UNITED STATES PATENT AND TRADEMARK OFFICE

| APPLICATION NO. | FILING DATE | FIRST NAMED INVENTOR | ATTORNEY DOCKET NO. | CONFIRMATION NO. |
|-----------------|-------------|-------------------------|---------------------|------------------|
| 10/775,970 | 02/11/2004 | Jonathan Eugene Brunson | | 9668 |

Office Action Summary

DETAILED ACTION

color and image frequency interfaces (column 10, lines 43-47) that allow an individual to project color images to the display tiles 3. Figure 3b of Lowry is reproduced below.

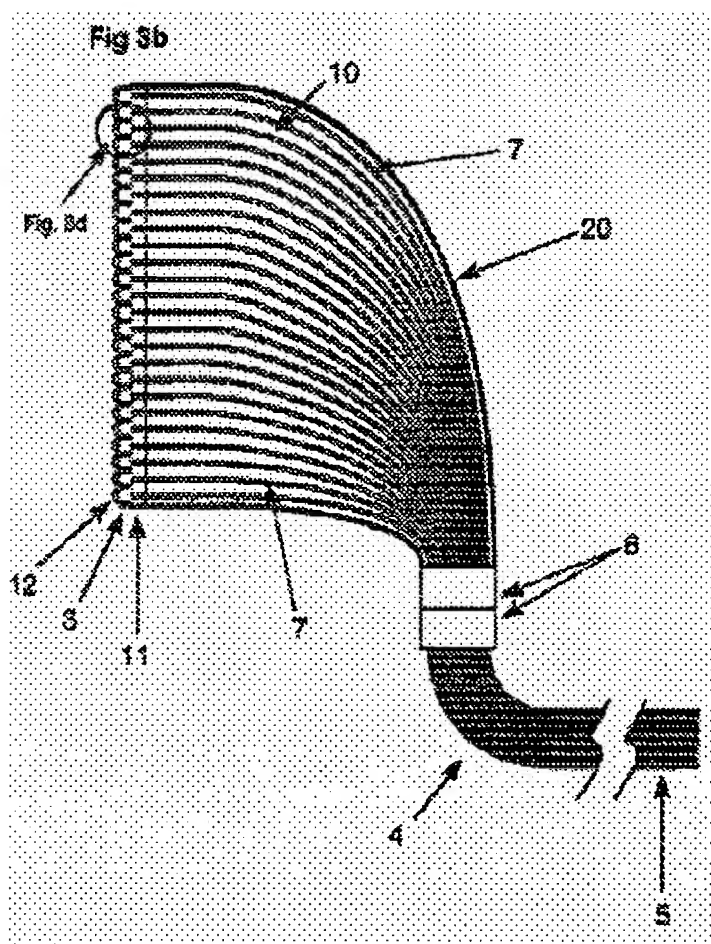
Regarding claims 1, 6, 11, and 16, to the extent the claims are definite, Lowry discloses a fiber optic system comprising:

display tiles or panels 3 that hold glass optical fibers 7;

Regarding claims 2, 3, 7, 8, 12, 13, 17, and 18 the video projector 18 and input matrix 13 of Lowry meet the specified limitations.

Regarding claims 4, 9, 14, and 19, Lowry discloses connecting fiber optic strands 4.

that allow an individual to project color images inside the fiber optic glass panels 21. Figure 1 of Strein is reproduced below.

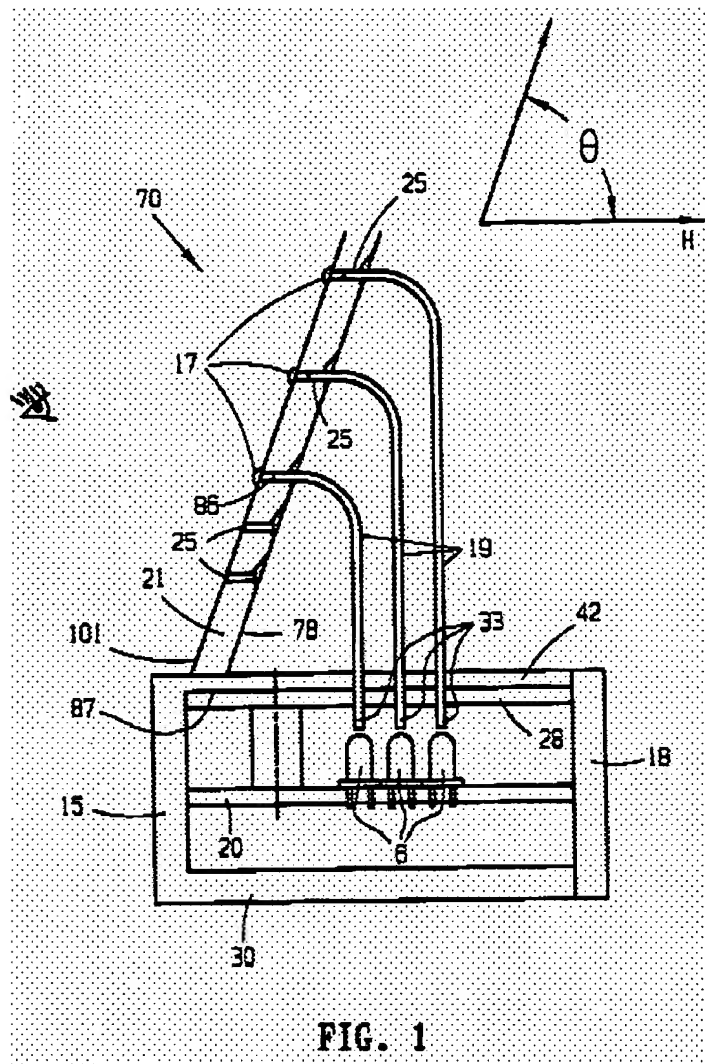
Regarding claims 1, 6, 11, and 16, to the extent the claims are definite, Strein discloses a fiber optic system comprising:

fiber optic glass panels 21 (see also column 10, lines 29-33);

a controller comprising color and image frequency interfaces (column 10, lines 29-53)

Regarding claims 2, 3, 7, 8, 12, 13, 17, and 18 the LEDs 6 shown by Strein meet the specified limitations.

Regarding claims 4, 9, 14, and 19, Strein discloses connecting fiber optic strands 19.

Regarding claims 5, 10, 15, and 20, Strein discloses an optical lens 17 for expanding the color or images within the display panel 21.
